WASTE & SERVICING STRATEGY ADDENDUM

Salboy Central Ltd

Viadux Phase 2 Minor Material Amendment

Project: Viadux Phase 2

Figure 3.1 Bin Store Location on Trafford Street

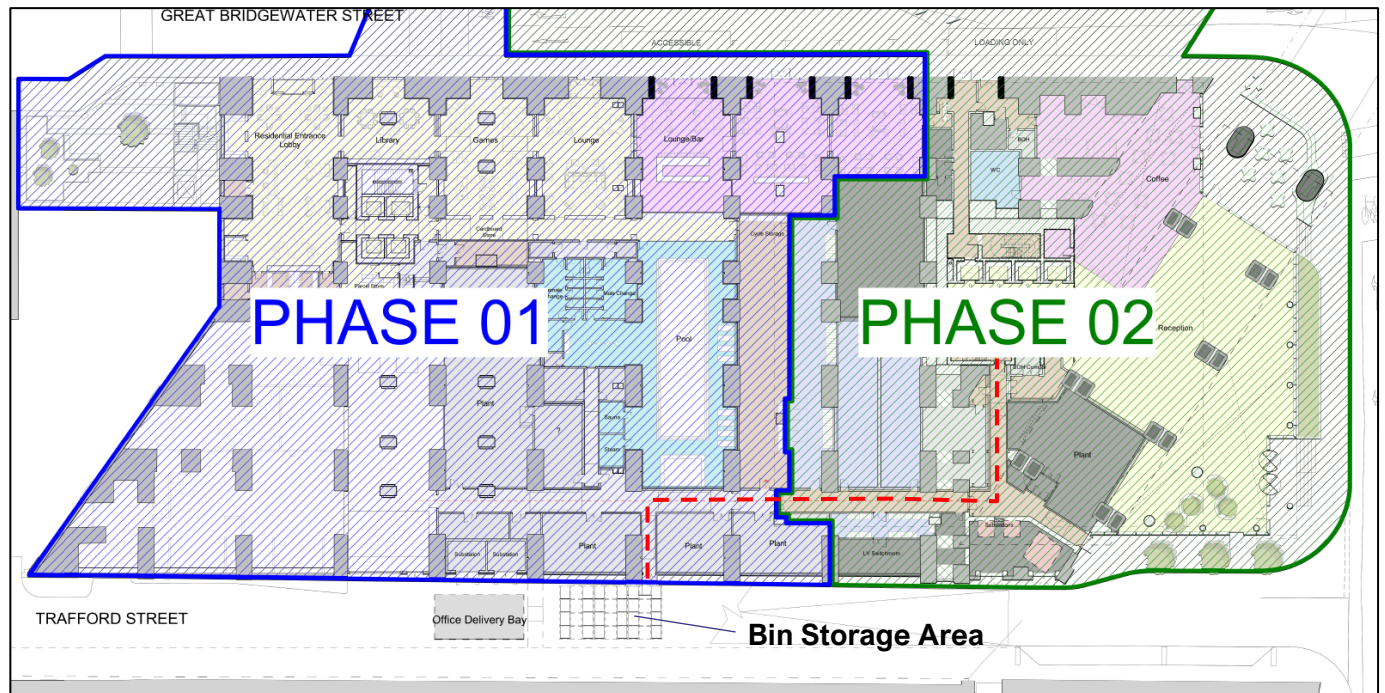
- 3.10 The bin storage area is shown in **Figure 3.1** below using the existing secure storage area. Within the storage area there is space for other occasional waste (such as furniture) to be stored.

2. Servicing and substations

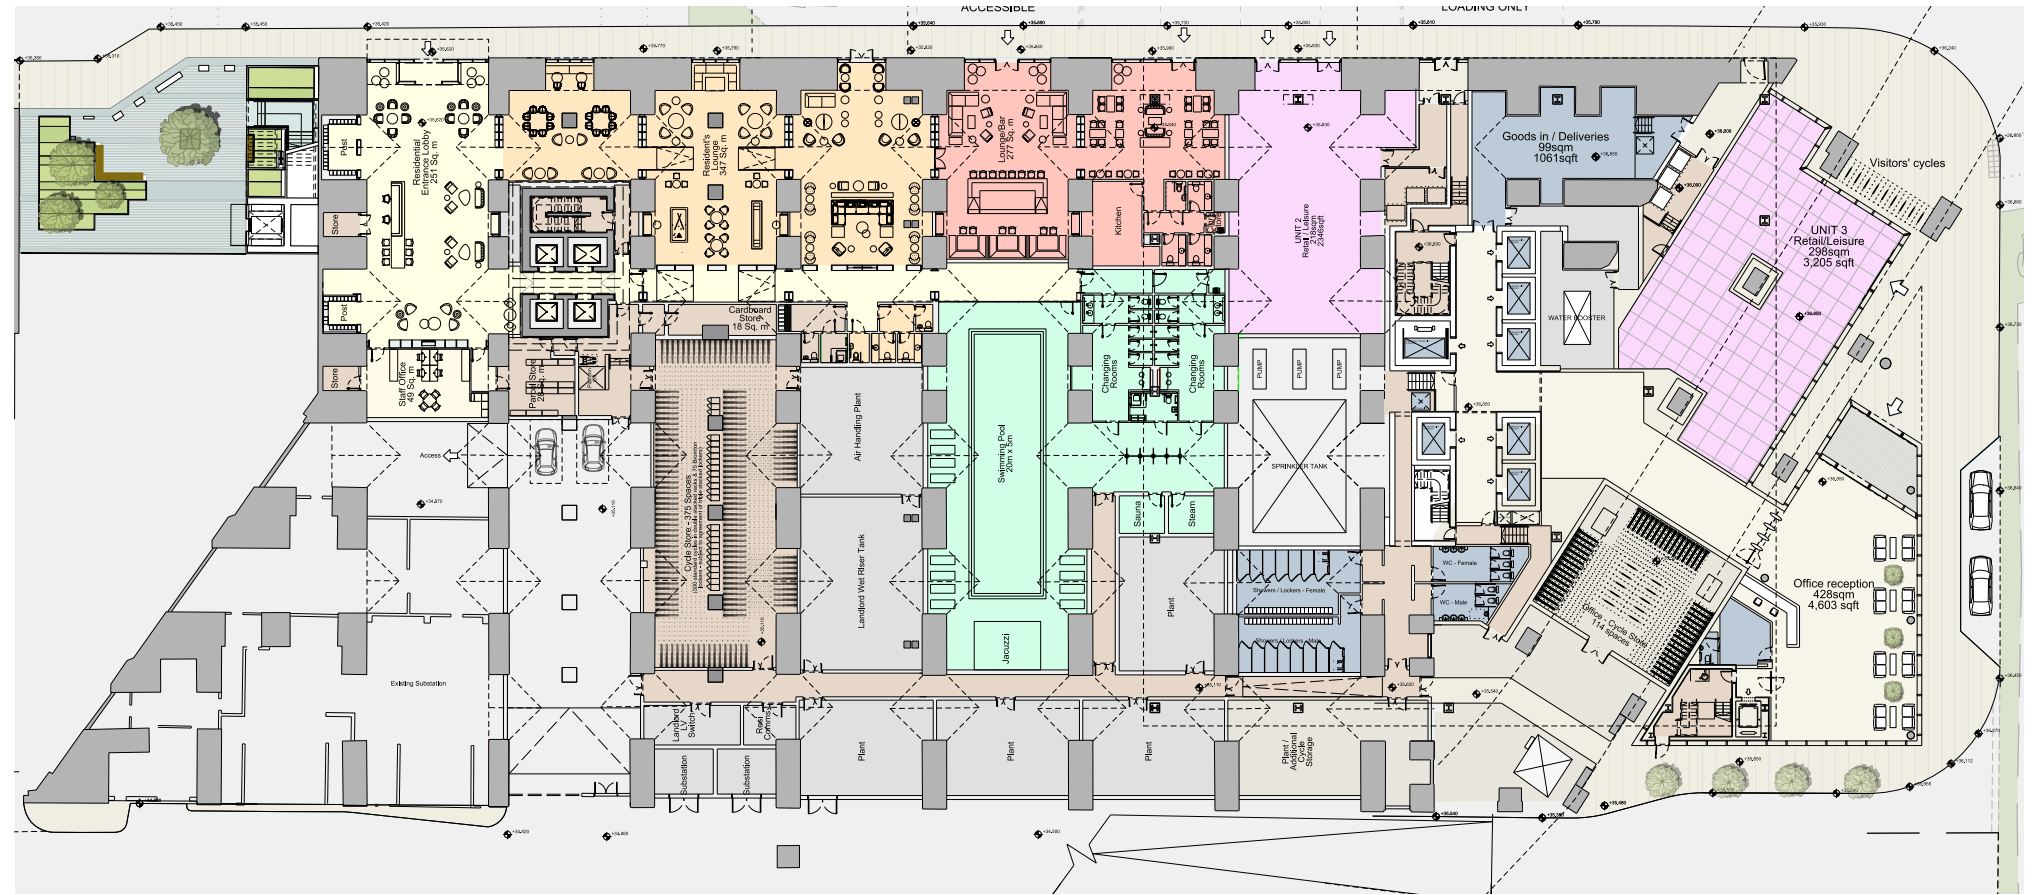
C - The main servicing of the office has been moved from Level 01 (Man Central service yard) to Trafford Street.

D - The refuse storage at Level 01 has been relocated underneath the existing servicing ramp to Man Central service yard.

E - The lay by to Albion Street has been omitted and the full pavement width restored improving the pedestrian environment. (Lounge bar / coffee shop servicing remains from the loading area on Great Bridgewater Street.)

F - The substations have also been relocated from Level 01 Man Central service yard to ground floor with direct access from the service road to Albion Street.

4. Office foyer & entrance

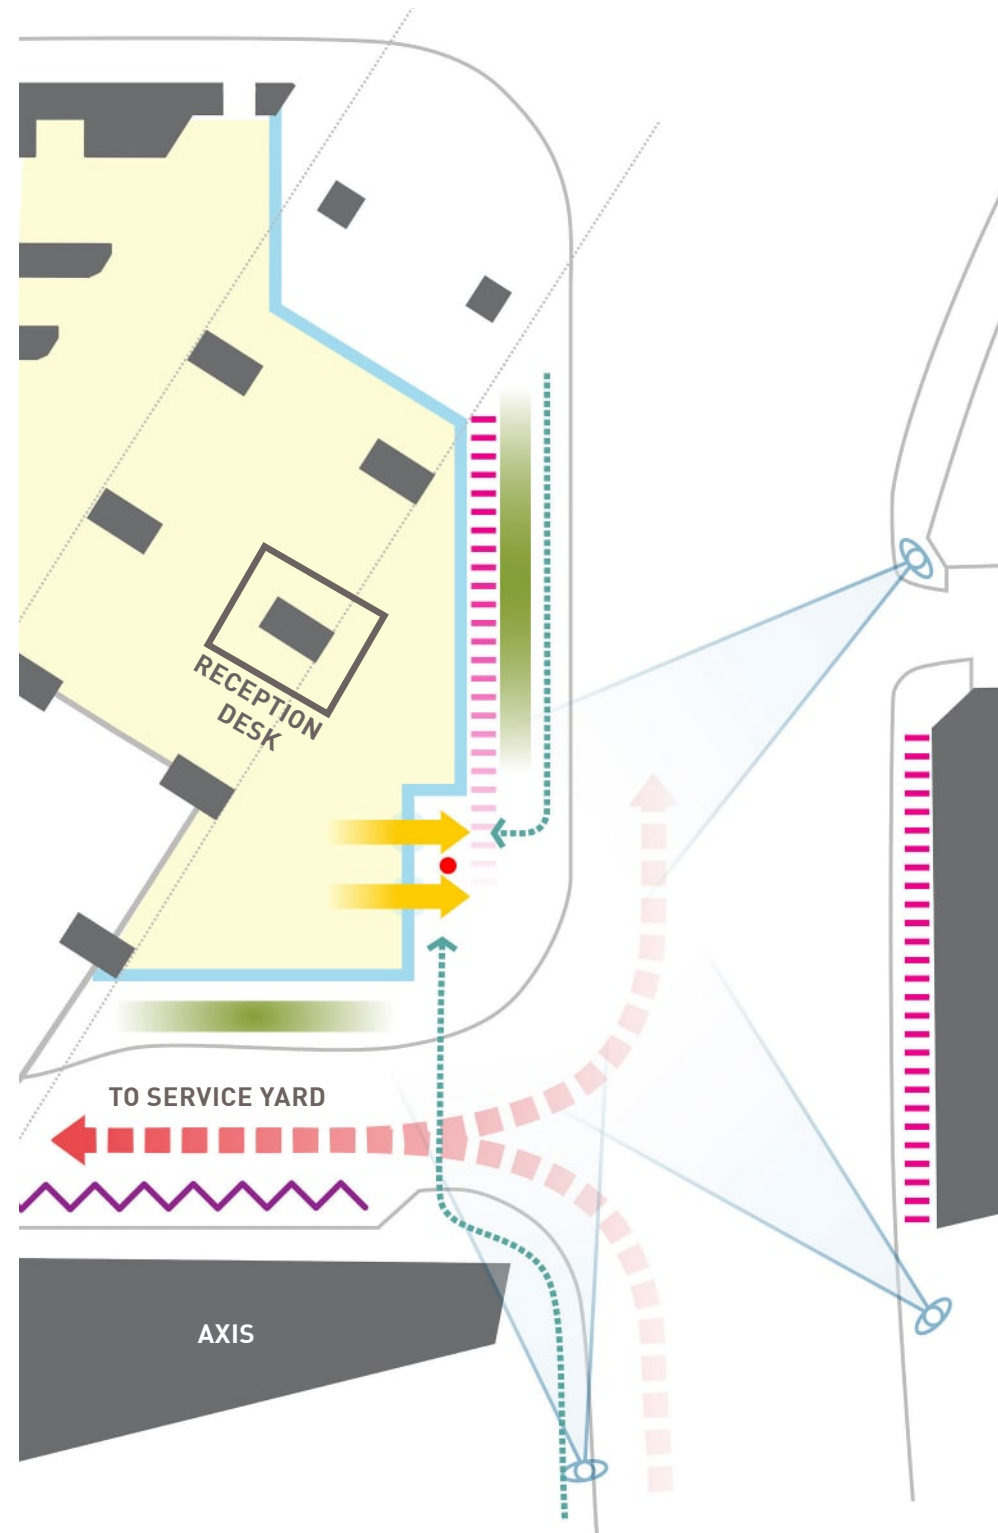
A - The pavilion building upper office floors and core (2 no. 250sqm floors) have been omitted to provide a triple height entrance foyer and sense of arrival commensurate with an office development of this scale.

B - The office entrance has been moved further down Albion Street to remove internal level changes and increase the headroom available underneath the tram bridge.

C - The reception desk has been relocated underneath the encapsulation with improved visibility of the lift lobby, entrance foyer and coffee shop.

D - The office cycle store, changing facilities, plant have been reconfigured to enable the cycles to be positioned within the historic arches and plant under the metrolink bridge.

E - Access to the cycle store is gained from Albion Street and the facade has been developed as an extension of the glazed pavilion building facade which wraps under the tram encapsulation to form the entrance. The substation facade underneath the tram bridge has been designed as a series of louvred panels, which are continued as infills to the top portion of the viaduct arches for ventilating plant rooms. This continues the language from Trafford Street, behind the service ramp and with the louvres which interface from the Tram bridge to the Axis Building opposite.

PROPOSED ENTRANCE

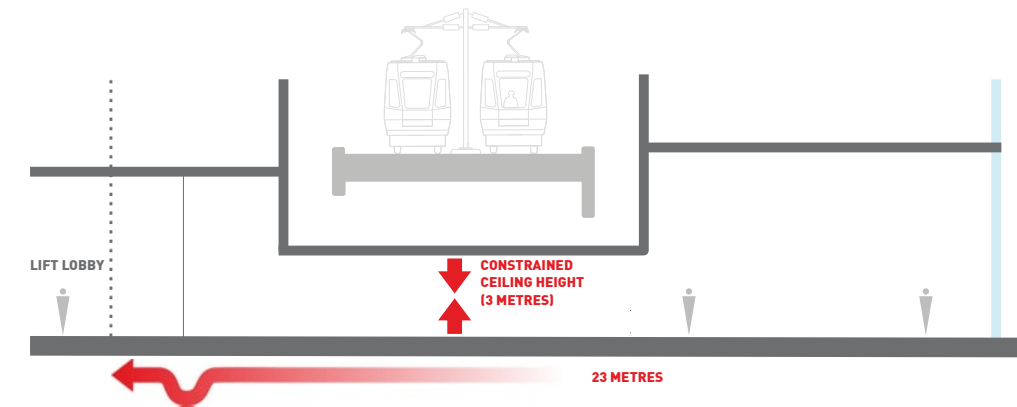
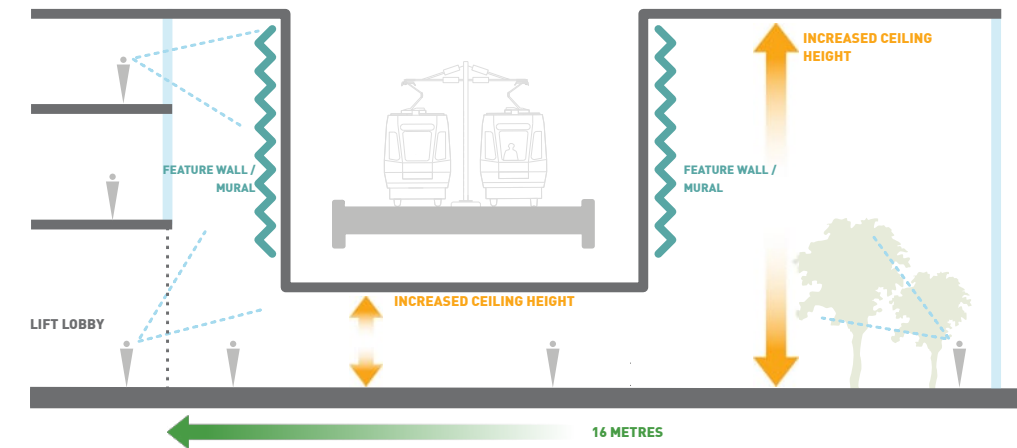
- Simplified geometry feels a more appropriate response
- Belongs to the orthogonal language of the pavilion
- Forms a strong corner
- Addresses Albion street and has clear visibility

- Lack of sense of arrival
- Constrained headroom under metrolink

- Creates a sense of arrival
- Incorporates tram encapsulation as artwork / mural
- Releases the space for amenity

8. Change to floor to floor height & additional floor

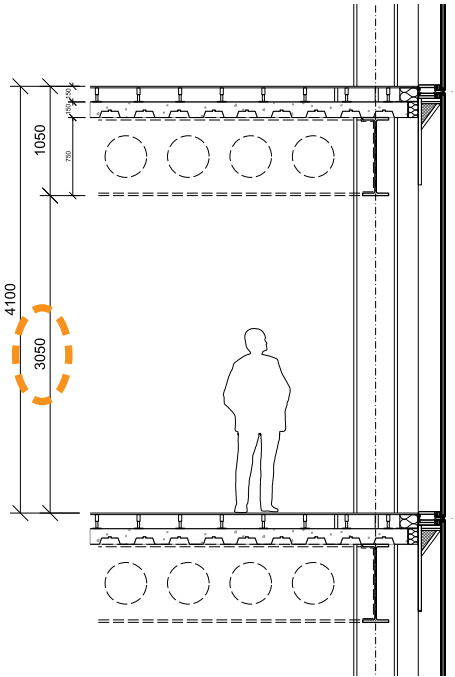
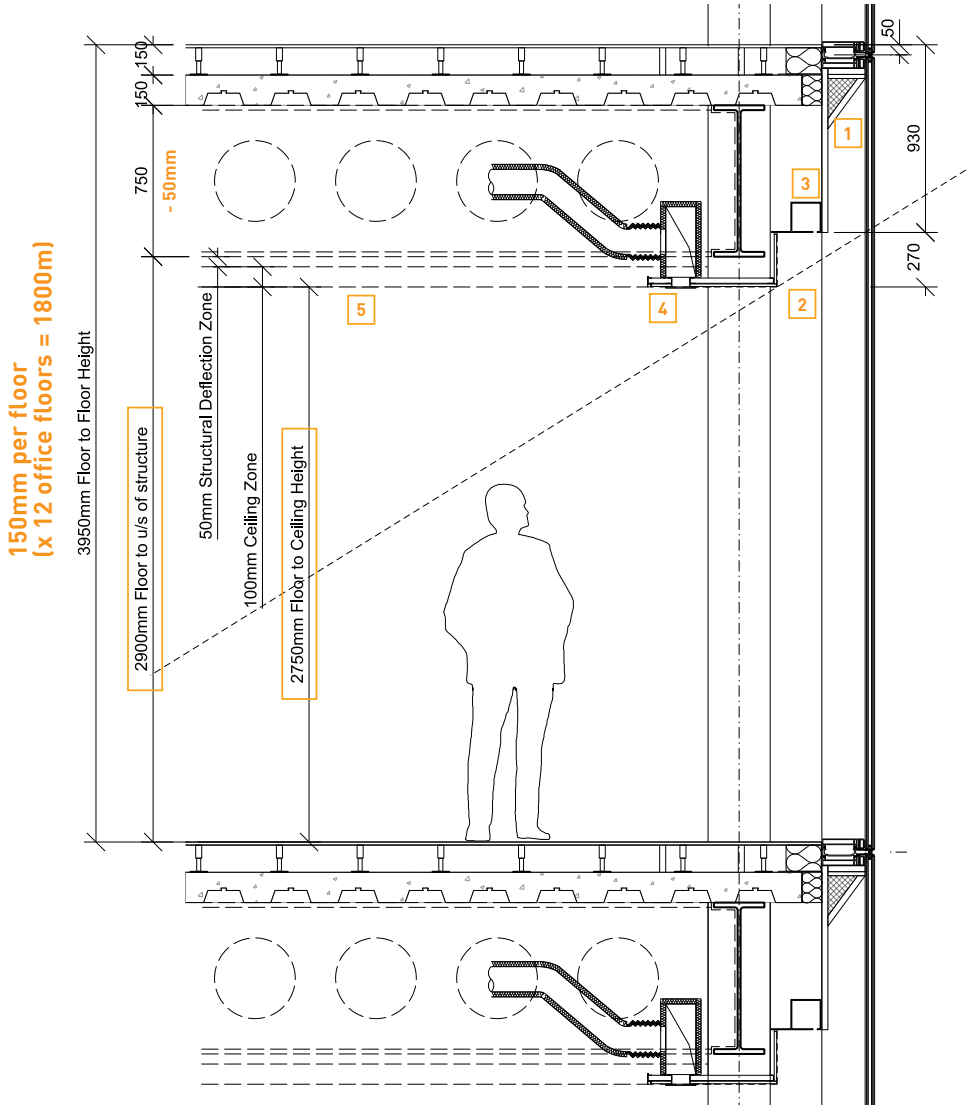
- A - The office floor to floor height has been revised following a review of the main structural beam depth and the client decision to have exposed soffits and services with no ceilings.
- As a result the floor to floor height has been revised from 4100mm to 3950mm with a 2900mm floor to underside of structure. (BCO Guide to Specification - Best practice for offices – 2019 recommends a clear height of 2.8 to 3.2m for spaces over 18m in depth).

- This provides a saving of 150mm per floor which equates to 1800mm over the 12 office floors.
- Further co-ordination of the distance required between the top of the Tram Encapsulation and the underside of the office level 02 structural slab also resulted in the need to raise the upper floors by 350mm. This ensures an adequate maintenace zone of 1200mm is maintained to allow for the inspection of the steelwork to the underside of level 02.
- B - The overall reduction in height of 1450mm (1800mm - 350mm) resulted in the decision to add a further office floor (3950mm) which results in an overall increase in height of 2500mm.

- The approved office building height is +108.300m AOD and the proposed office building height is +110.800m AOD.
- The additional floor offsets the omission of the pavilion building office floors, together with the provision of amenity space and green rooms to the main office floors.
- C - The overall office NIA has been increased by 12,110sqft (1,125sqm)
 - Approved NIA = 251,391sqft (23,355sqm)
 - Proposed NIA = 263,501sqft (24,480sqm)

Appendix B – Public Realm Amendments

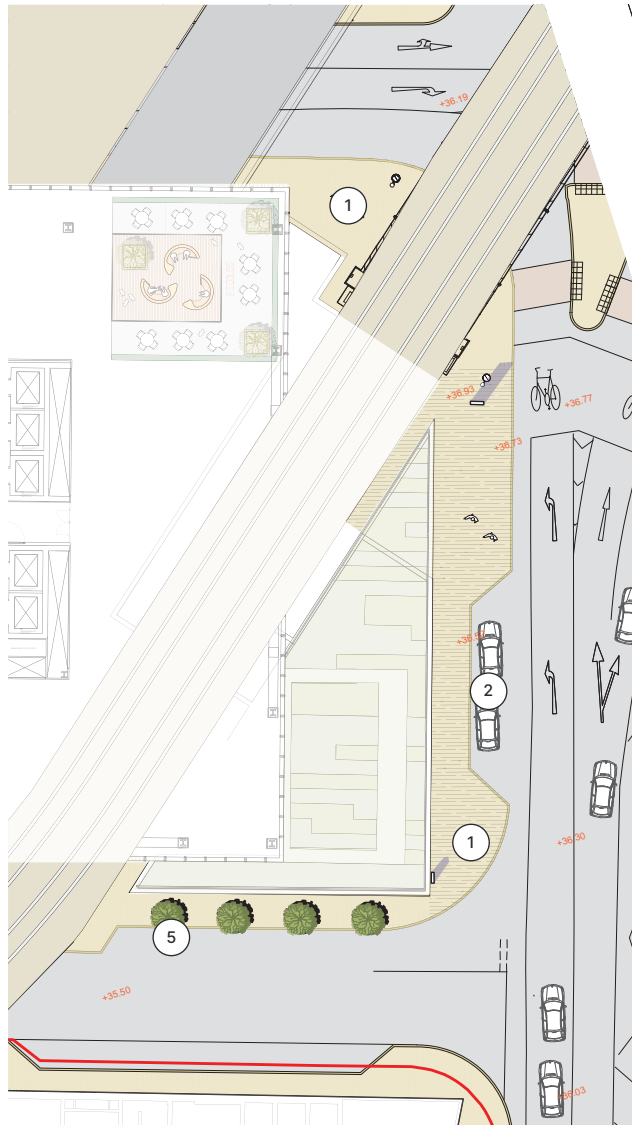
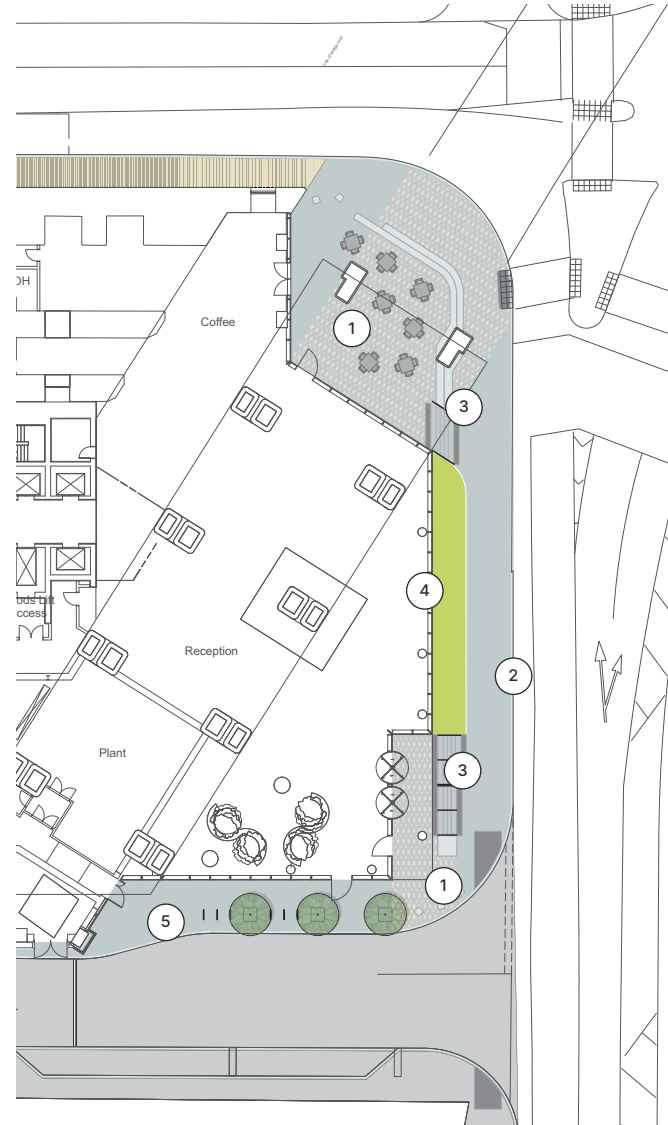
1. Paving materiality has been revised from yorkstone to granite with bespoke units.

2. Omission of loading bay to Albion Street.

3. Introduction of steps and seating walls.

4. Introduction of soft landscaping along eastern building elevation.

5. Omission of one tree to the south of the building.

Reason: To create a stronger sense of arrival, and acknowledgement of the heritage of the existing architectural features and heritage.

Reason: Servicing to be carried out from Trafford Street.

Reason: To accommodate level change around the site.

Reason: To enhance amenity and biodiversity value in the public realm and to provide a visual connection with the green elements on the building above.

Reason: Due to the tree pit clashing with existing services in the footway.
